City of Santa Fe

AGENDA

REGULAR MEETING OF THE PLANNING COMMISSION FEBRUARY 17, 2022 AT 6:00 PM MEETING VIRTUALLY

Case No:	2021-4377, 2021-4378, 2021-4379 and 2021-4381
Hearing Date:	February 3, 2022
Applicant:	The Pulte Group of New Mexico
Request:	General Plan Amendment, R-10 Rezoning, Preliminary Development Plan, and Preliminary Subdivision
Location:	16.21 acres on both sides of Caja del Oro Grant Road, east of the Alameda Frontage Road
Case Mgr.:	Donna Wynant
Zoning:	C-2 (General Commercial) and R-1 (Residential- one dwelling unit per acre)
Pre-app Mtg:	April 8, 2021
ENN Mtg:	May 11, 2021 & August 10, 2021
Proposal:	88 single-family residential lots on approximately 16.21 acres

FIGURE 3
EXISTING TRAFFIC VOLUMES

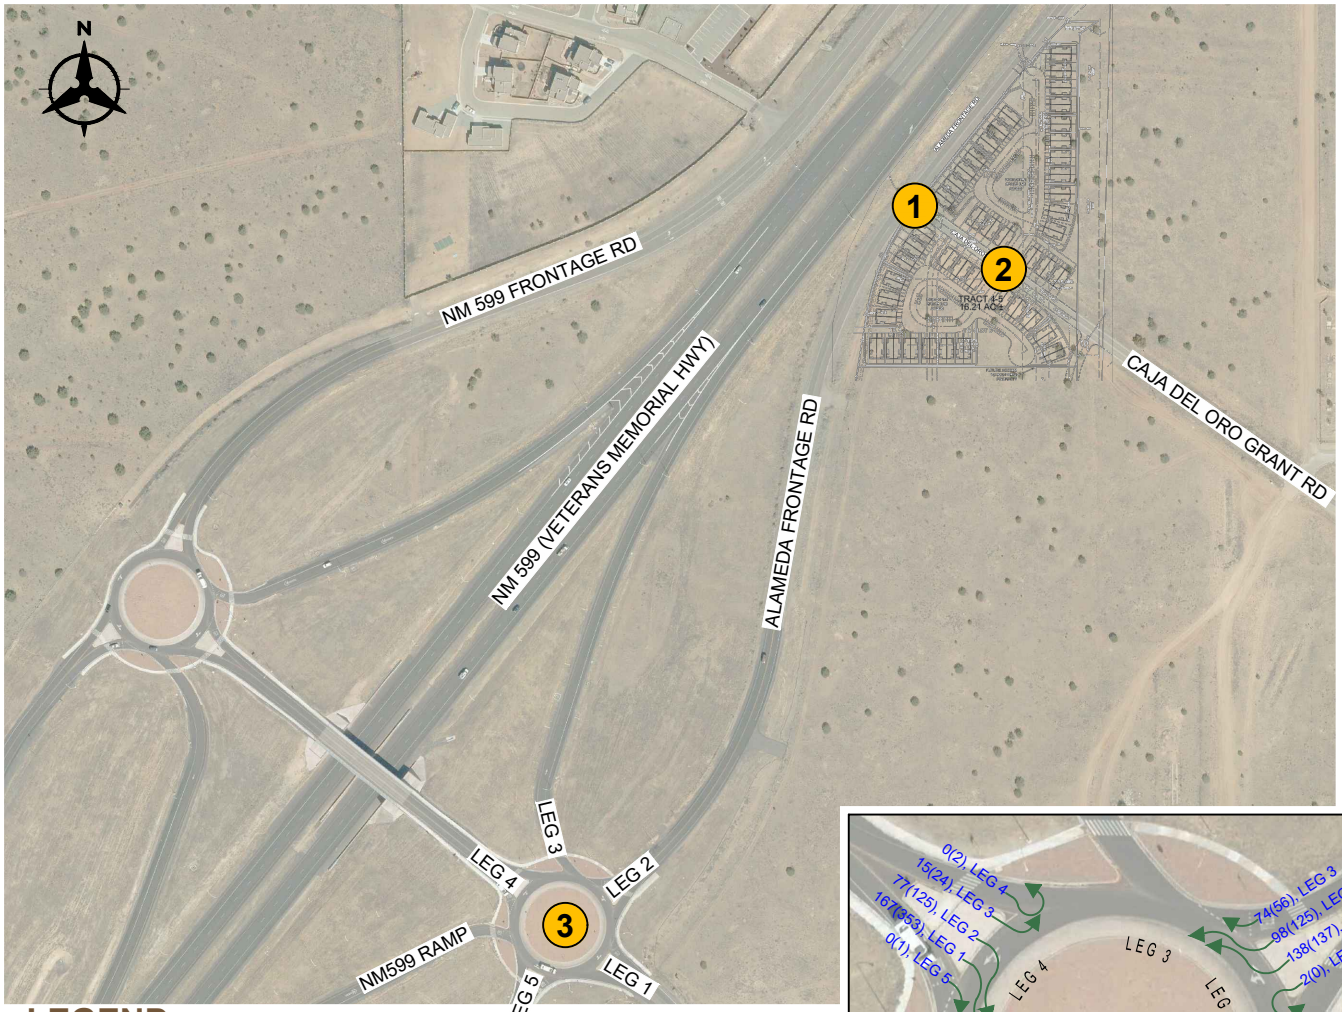
c. Table 7, Alameda Frtg. & Caja del Oro WB Left and Right, AM should be 125 and PM should be 175.
4. The following data on Figure 3 will need to be updated to match the data in the appendix

4		The following data on Figure 3 will need to be updated to match the data in the appendix a.Leg 1 to Leg 3 PM volume should be 160. b.Leg 2 to Leg 1 PM should be 137. c.Leg 2 to Leg 4 PM should be 125.	BH to update	A	BH	11/19/2021	
5		The following data in Table 6 will need to be updated to match the data in the appendix. a.599 Overpass PM Queue should be 100, based on 25 feet per car. b.Alameda Frtg. & Caja del Oro, Westbound Left & Right PM delay should be 36.3 and the V/C should be 0.65. The LOS should be E based on the printed report. The AM delay should be 23 and the V/C should be 0.58. c.Caja del Oro & Site Entrance north bound left should be 14.0 and the northbound right should be 10.9	BH to update	A	BH	11/19/2021	
6		On page 19, the paragraph about the westbound left and right approaches at Alameda Frontage and Caja del Oro Grant Road Intersection will need to be updated. The data shows that the PM peak hour will operate at LOS E	BH to update	A	BH	11/19/2021

FIGURE 8
2034 NO BUILD TRAFFIC VOLUMES

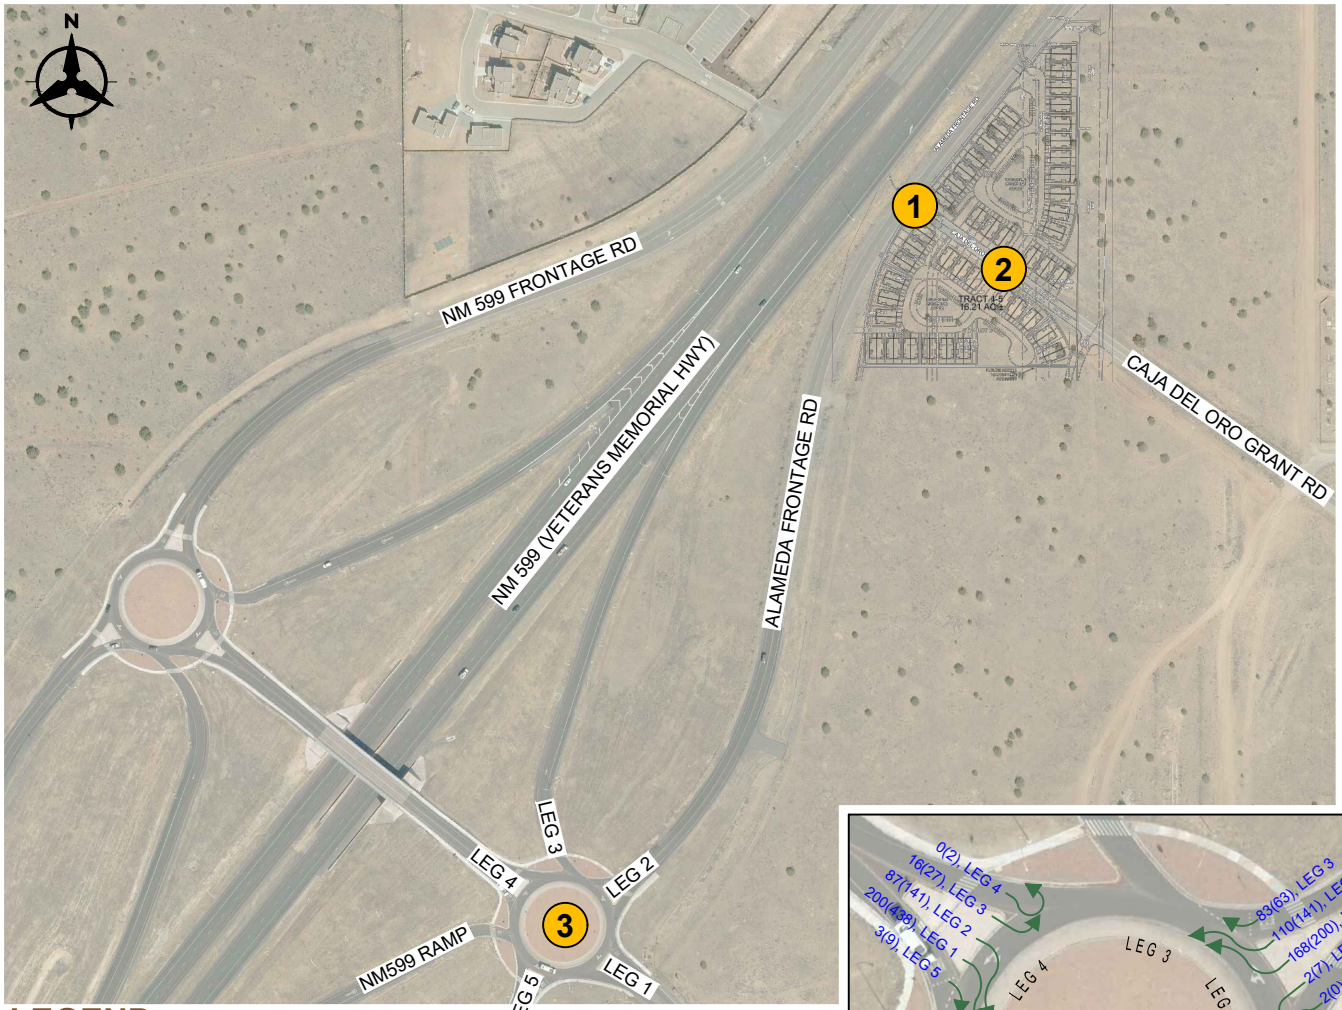
7. On Figure 8, the NM 599 Ramp to Leg 1 AM volume should be 89 to match the data in the appendix.
8. Appendix B title references 2020, while the report references 2021 for existing conditions.

7		On Figure 8, the NM 599 Ramp to Leg 1 AM volume should be 89 to match the data in the appendix	BH to update	A	BH	11/19/2021	
8		Appendix B title references 2020, while the report references 2021 for existing conditions.	BH to update	A	BH	11/19/2021	
9		Appendix D and E title imply there is only 2024 data. I recommend either updating the title to reflect the inclusion of the 2034 data or breaking the 2024 and 2034 into separate appendixes.	BH to update	A	BH	11/19/2021
